# Bulletin Number - BP4C KVC - 02

<b>Project</b>	Steamboat Base Village Redevelopment	<b>Date</b>	12/13/2021
<b>Project Location</b>	Steamboat, Colorado	<b>Architect's Project Number</b>	03.7835.000
<b>Owner/Client</b>	Alterra Mountain Company / East West Partners	<b>File</b>	6BL <b>This is page</b> 1 of 2
<b>To</b>	Saunders Construction Inc.	<b>Attention</b>	Bryan Sculthorpe
<b>Address</b>	86 Inverness Place North		
<b>City</b>	Englewood	<b>State</b>	CO <b>Zip Code</b> 80112
<b>Delivered via:</b>	<input type="checkbox"/> <b>Messenger</b> <input type="checkbox"/> <b>Hand carried</b> <input type="checkbox"/> <b>Facsimile</b> <input type="checkbox"/> <b>Express</b> <input type="checkbox"/> <b>Pick-up</b> <input type="checkbox"/> <b>E-mail Address</b> <input type="checkbox"/> <b>Mail</b> <input type="checkbox"/> <b>UPS</b> <input checked="" type="checkbox"/> <b>Website Address</b> BIM360

### Description of Changes

- Updated MEP and arch roof plan
- Updated steel reinforcing for roof (sketch)

DETAIL NO:  
**SSK-1**

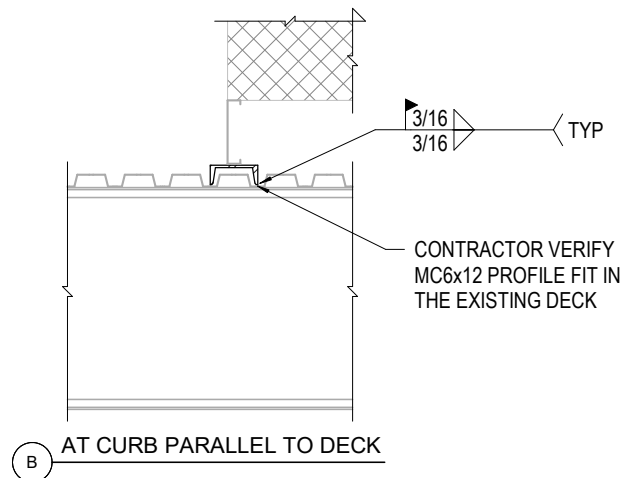
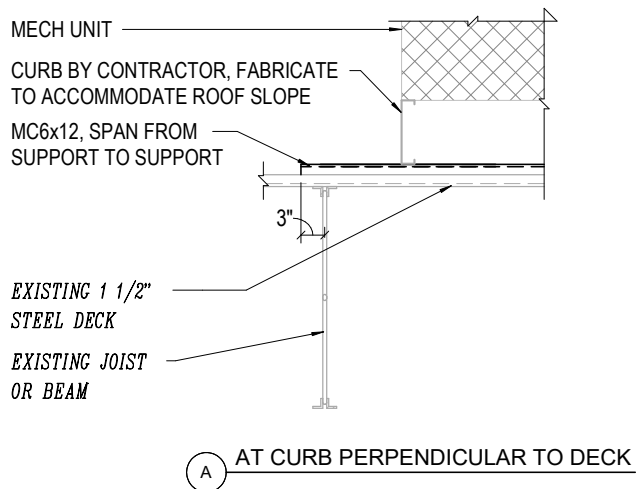
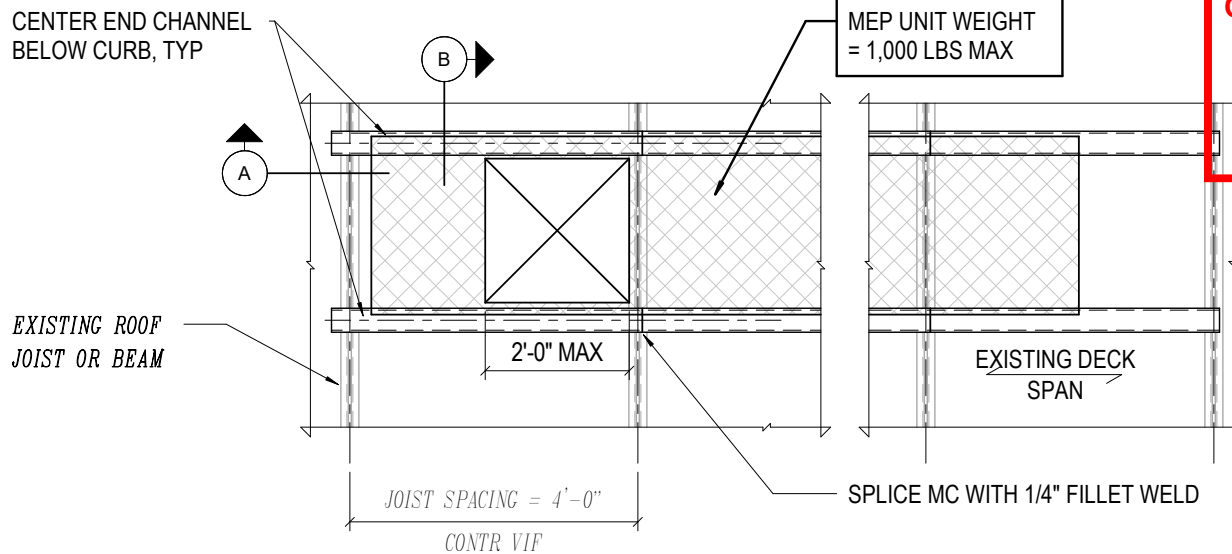
- Structural Sketch SSK-1
  - Structural Supplemental Detail For MEP Roof Requirements

**1C-I1.202**

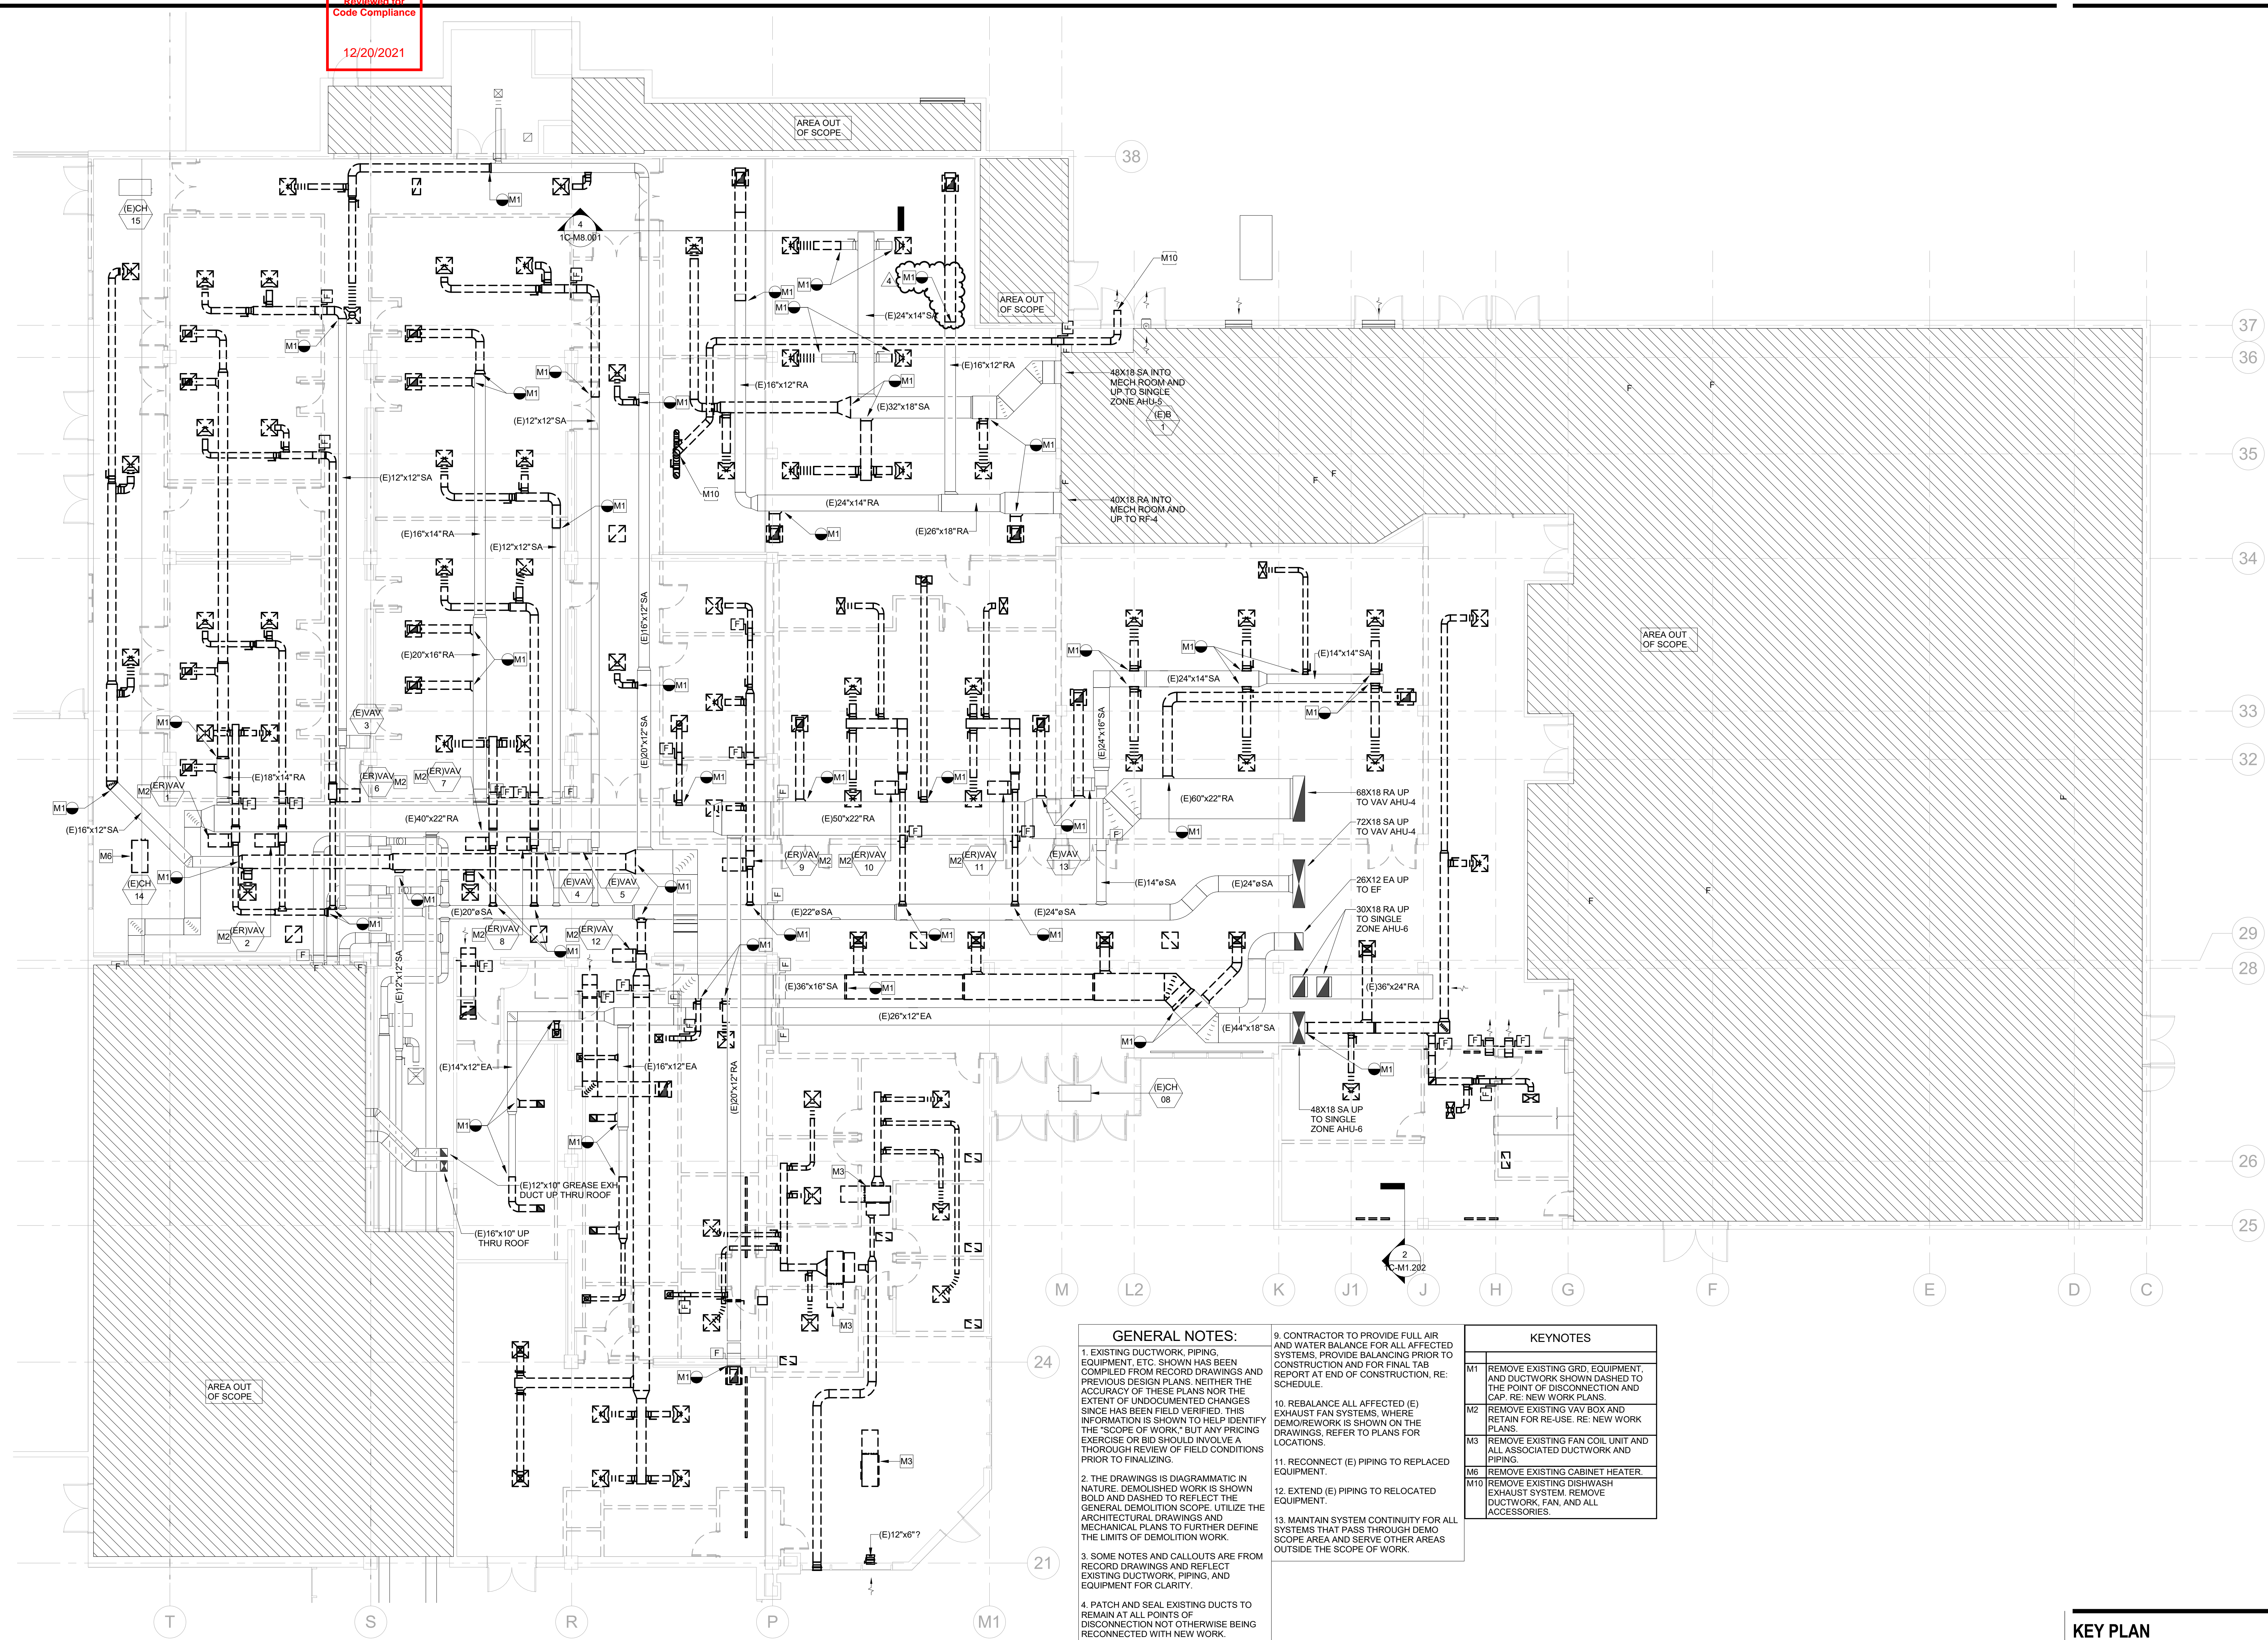
- 1C-I1.202
  - Revised roof plan with updated changes.

**1C-DM1.101**

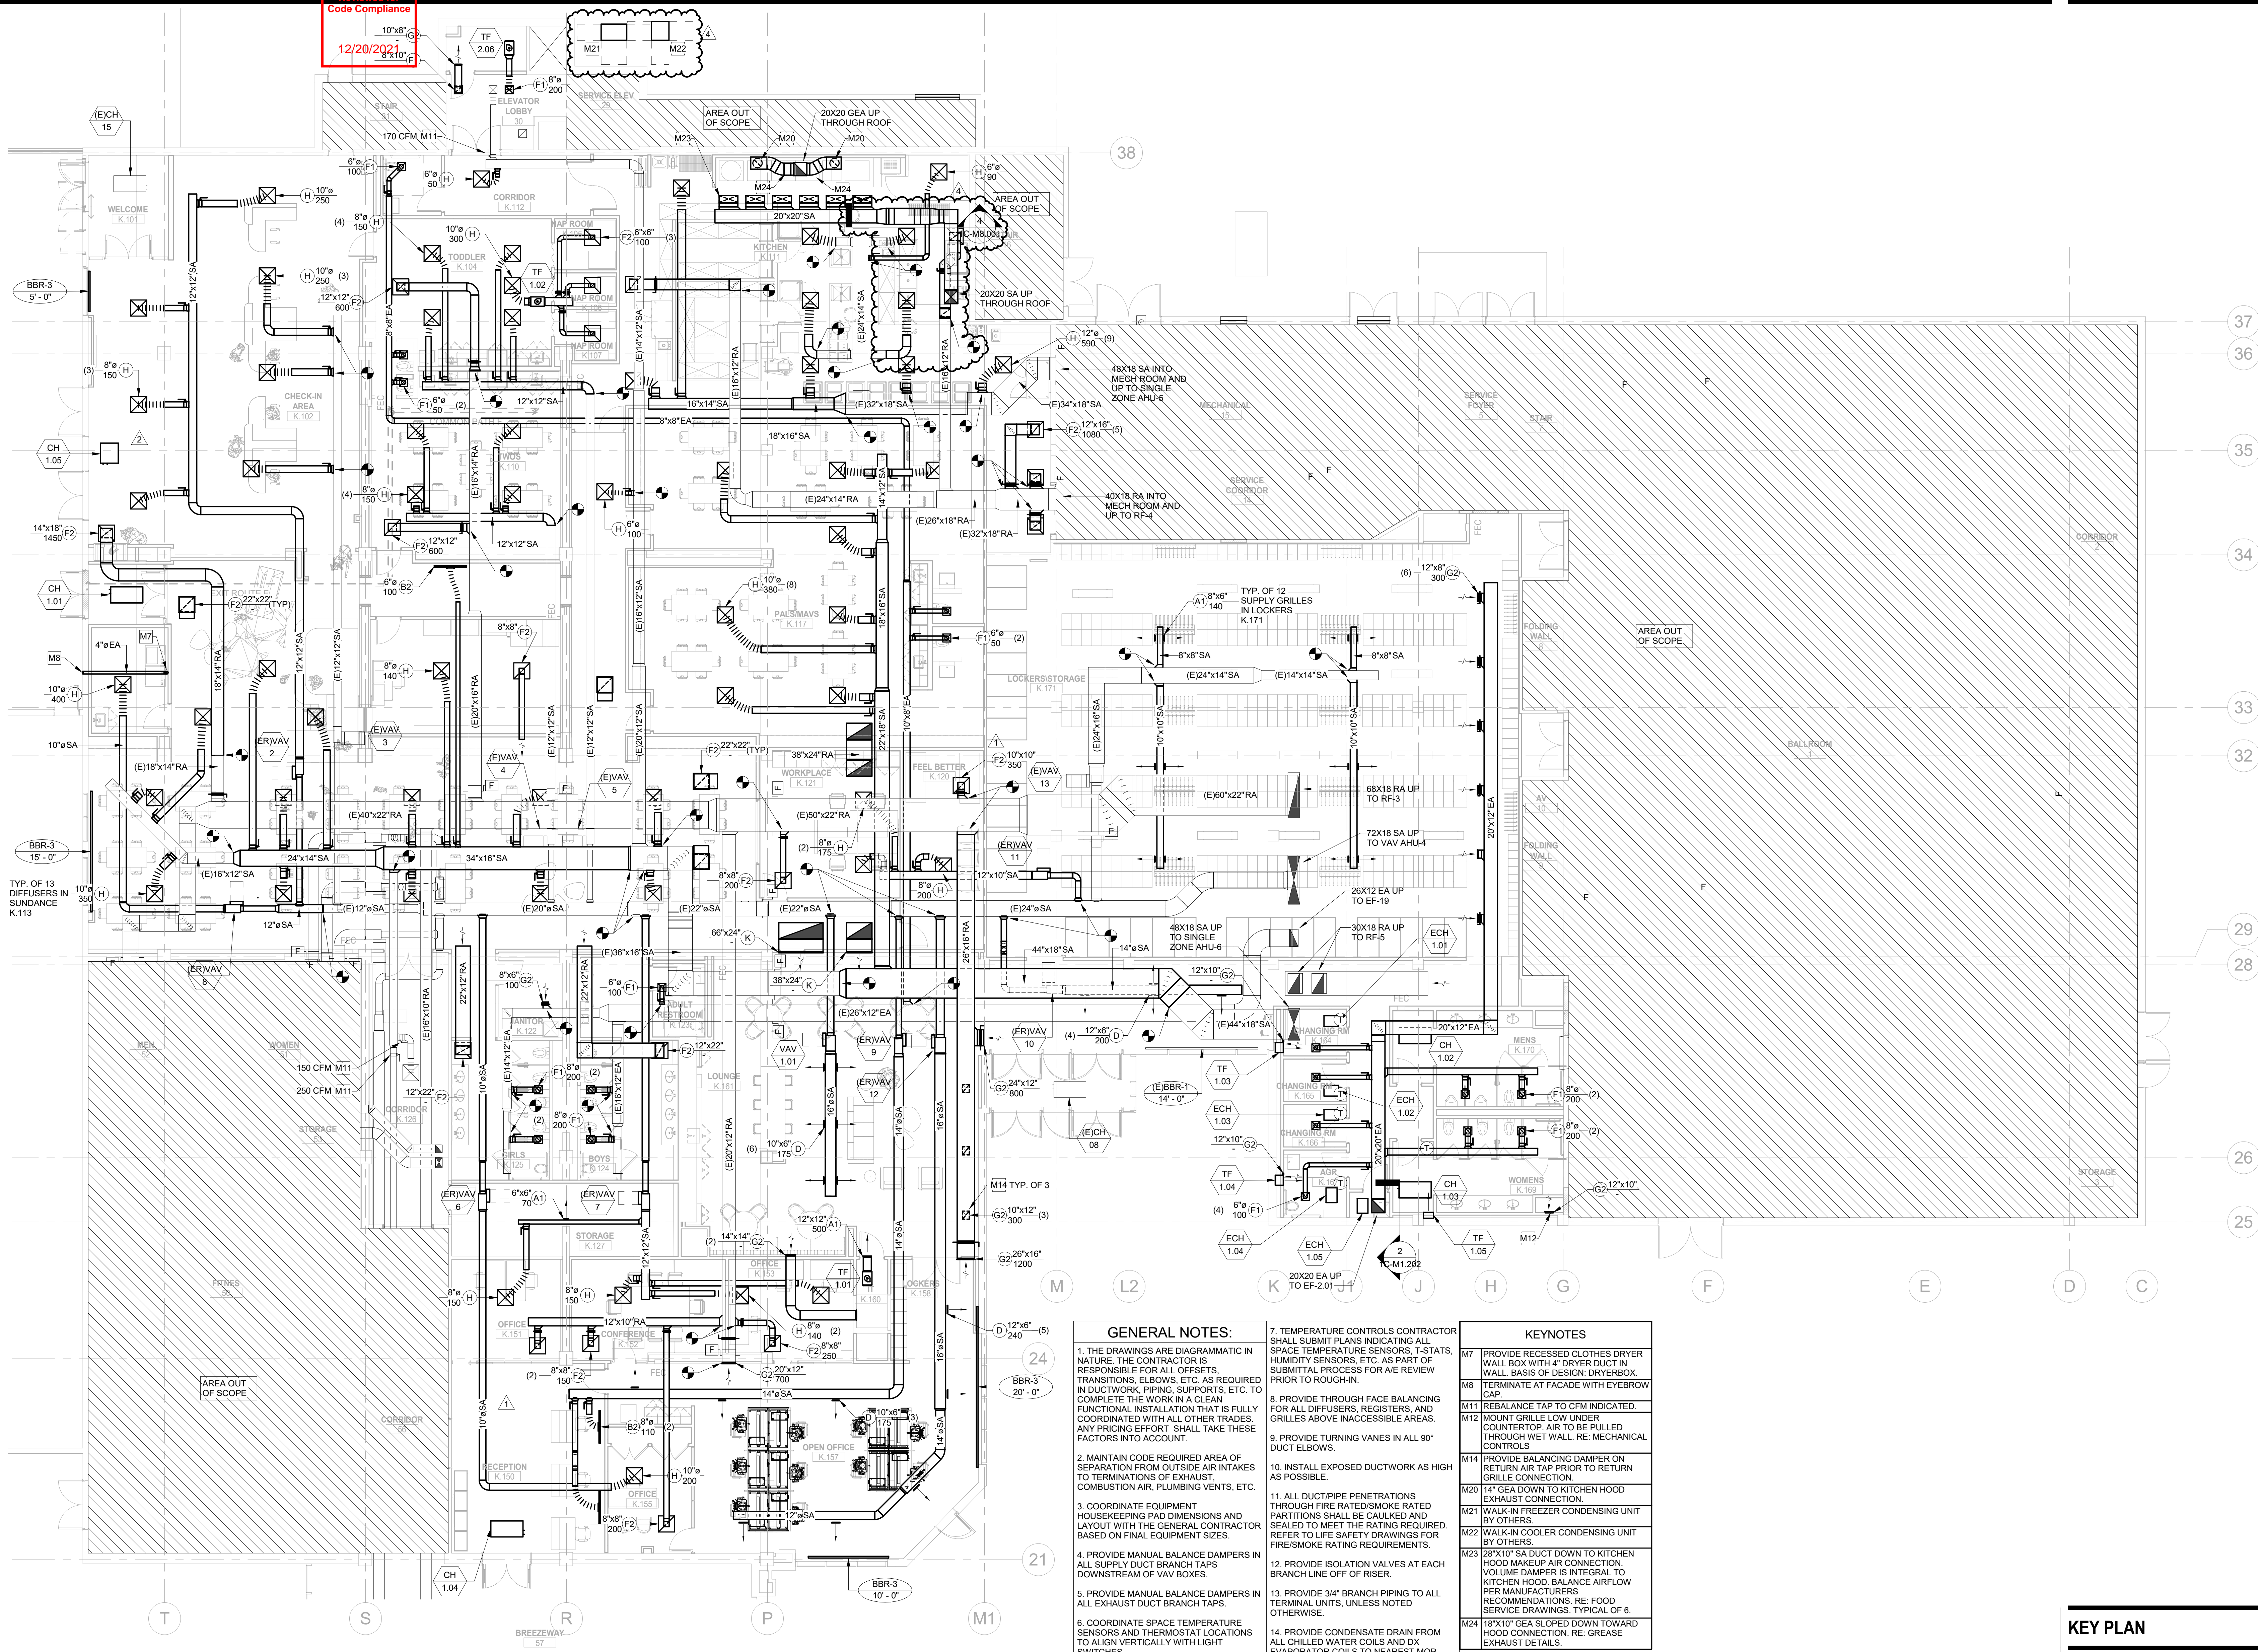
- 1C-DM1-101
  - Revised demolition scope
- 1C-M1.201
  - Relocated walk-in cooler condensing unit to grade level outside building.
  - Revised sheet metal layout in kitchen to accommodate existing hydronic piping mains.
- 1C-M1.202
  - Relocated grease exhaust fan and makeup air unit on roof. Relocated food service condensing units to grade level outside building.
- 1C-M8.001
  - Added detail for sheet metal around existing hydronic piping mains.
